Central Precinct Renewal Program

Aboriginal Heritage Study
Addendum

August 2023

Figure 2: Revised Urban Design Framework (Source: Architectus, 2023)

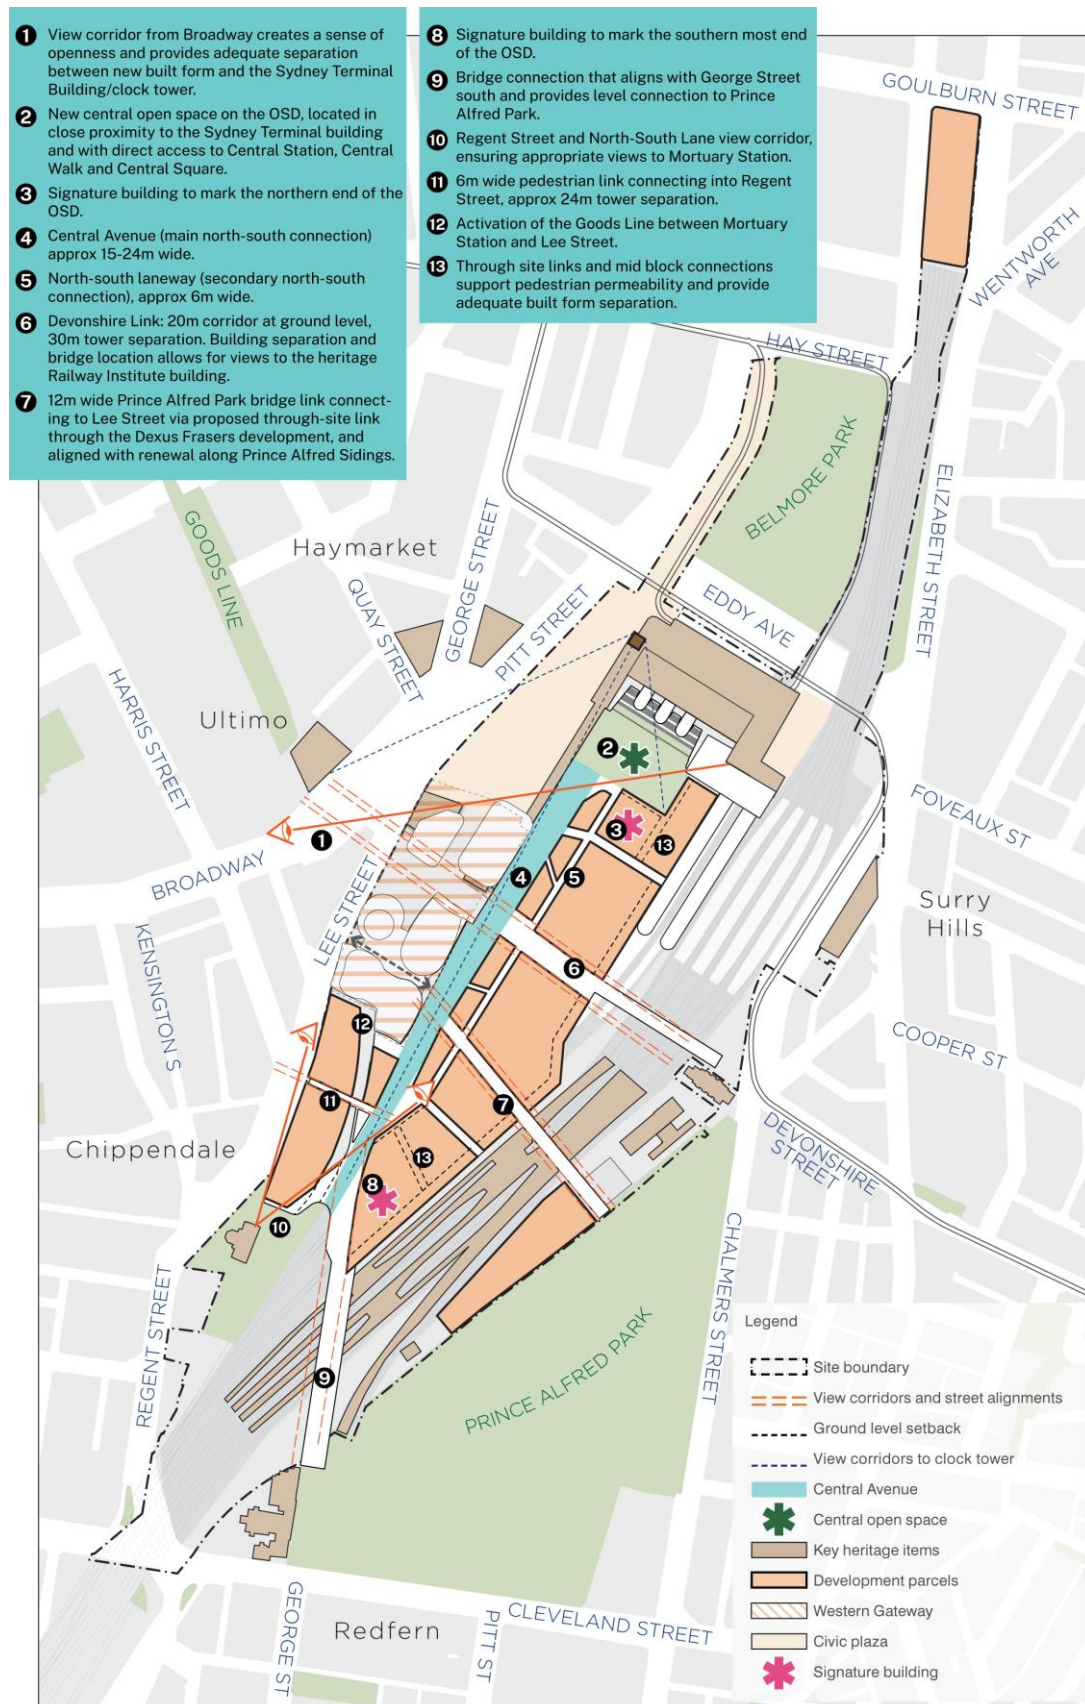
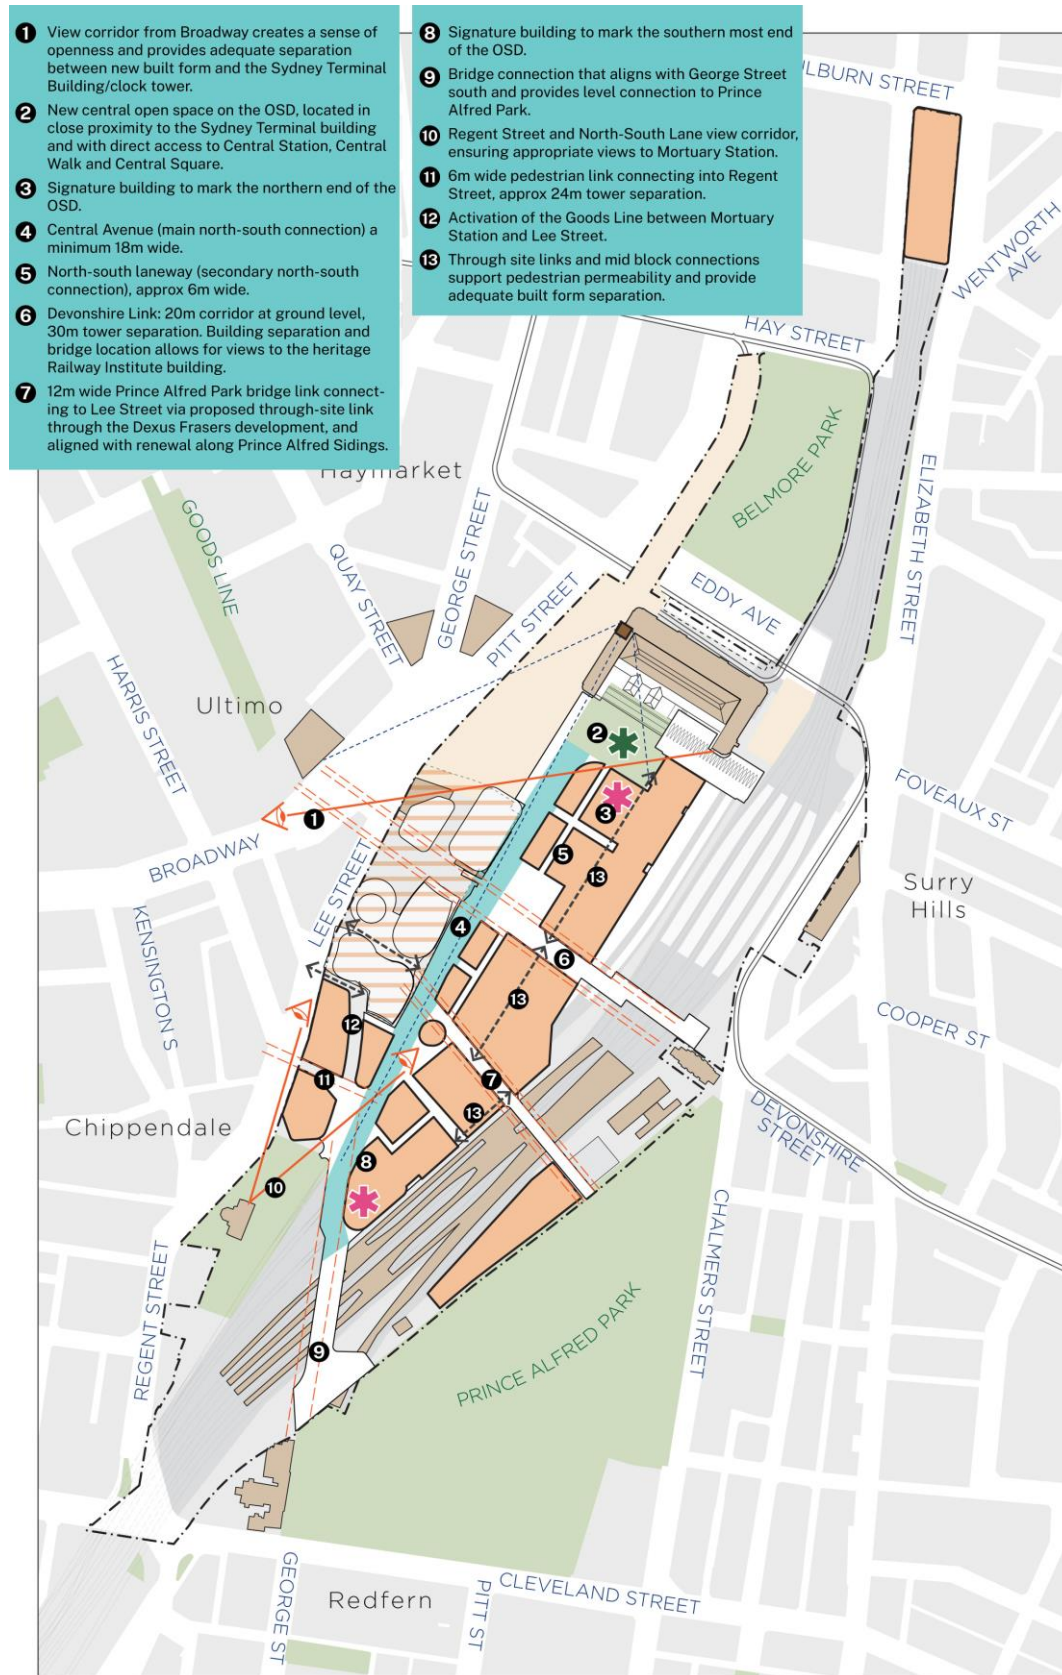
- **Improved interface between Terminal and OSD:** The interface relationship between the OSD deck and the Terminal Building has been further rationalised to improve the function of the station as a major interchange and better respect the heritage of Central Railway Station. The following changes have been made:

- a reduced spatial extent of the stairs between the OSD deck and the Terminal to now be a consolidated vertical connection (stairs, lift and escalators) to the north-eastern edge of Central Green

- an expanded concourse level with greater access to daylight and new opportunities for landscaping that will improve the passenger experience on the platforms and in the concourse, compared to the exhibited proposal

- incorporating an interpretation of the platform canopies to deliver a heritage-responsive and weather-protected connection.
- **Consistent 18-metre-wide Central Avenue:** A consistent width of 18 metres has been provided for Central Avenue. The future role and function of this link has been revised from an avenue between the north and south of the OSD deck to now becoming a connector of a sequence of public spaces on the OSD deck.

- **Additional mid-block through-site links:** The introduction of additional mid-block connections to reinforce breaking up the podiums on the OSD deck level into interconnected smaller building forms.

- **Removal of the Eastern Colonnade:** The eastern colonnade has been removed from the revised Reference Masterplan.
- **Reconfiguration of Central Green:** The layout of Central Green has been adjusted to be a squarer geometry compared to the exhibited proposal. The primary movement path through Central Green is now focused toward the southern and eastern edges of this open space. The indicative design of Central Green has also been adjusted to improve its relationship with the Terminal Building through the incorporation of seating and greater landscaping at the northern edge of the park.

- **An enlarged Mortuary Station Plaza:** The reduction of the podium building envelope of the Regent Street Sidings building brought about through changes to the bus layover and basement entry /exit pathways provide for an enlarged public space at Mortuary Station Plaza by 2,030 square metres to a total area of 6,500 square metres. The increase in the size of this public space also presents the opportunity to retain the existing fig tree at Mortuary Station and provide a new playground that is accessible to the broader community.

- **Devonshire Square:** A new square of approximately 2,700 square metres has been included into the revised Reference masterplan at the junction of Central Avenue and the Devonshire link, which will provide a new civic space at the entry point to the proposed extended Central Walk. (Central Walk will provide access to all of the rail platforms in Central).

- **Southern Plaza:** A new reconfigured civic space of approximately 4,700 square metres at the southern end of Central Avenue, providing a new arrival and meeting space when coming from the south. Within the Southern Plaza, there is the potential for a marker building that is designed with a Connecting with Country focus.

- **Regent Street Sidings:** The podium envelope at Regent Street Sidings has been further rationalised to improve the integration between the OSD deck level and Regent Street
